## Safety Recall Action Notice SB567 Issue 1 - 11.2019

Subject: Gear Linkage Clamp Assembly Replace				
Notice Number	Models Affected	VIN Range		Markets Affected
567	Speed Triple RS	From	898139	US and Canada Markets Only
		Up to	970149

1. **Recalled part - Linkage clamp assembly, T2085085 (without scallop) - Referred to throughout as Gear Linkage Clamp Assembly**
2. **Remedy part - Linkage clamp assembly, T2085100 (with scallop) - Referred to throughout as Gear Linkage Clamp Assembly**

1. Gear linkage clamp assembly (T2085085)
2. Alignment marks
3. Fixing

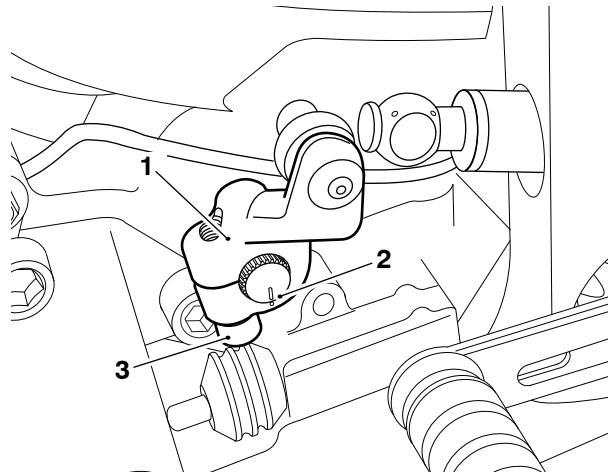
- 
3. Remove and retain the gear linkage clamp assembly fixing. Remove the gear linkage clamp assembly (T2085085).

1. Gear linkage clamp assembly (T2085100)
  2. Alignment marks
  3. Fixing
2. Install the clamp fixing and tighten to **8 Nm**.

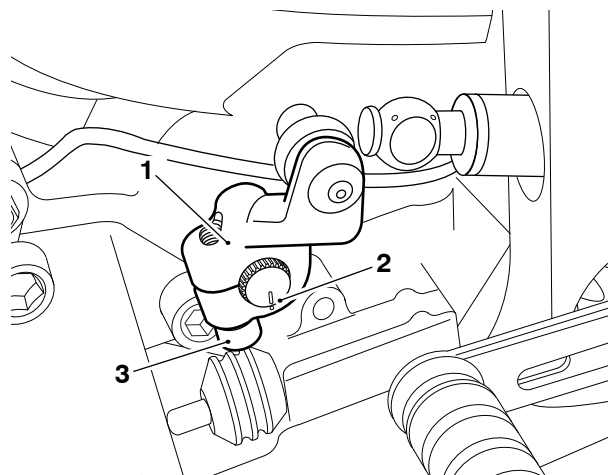
1. Make sure the alignment mark on the gear shaft assembly aligns with the alignment mark on the gear linkage clamp assembly (T2085100) and install the clamp to the shaft.
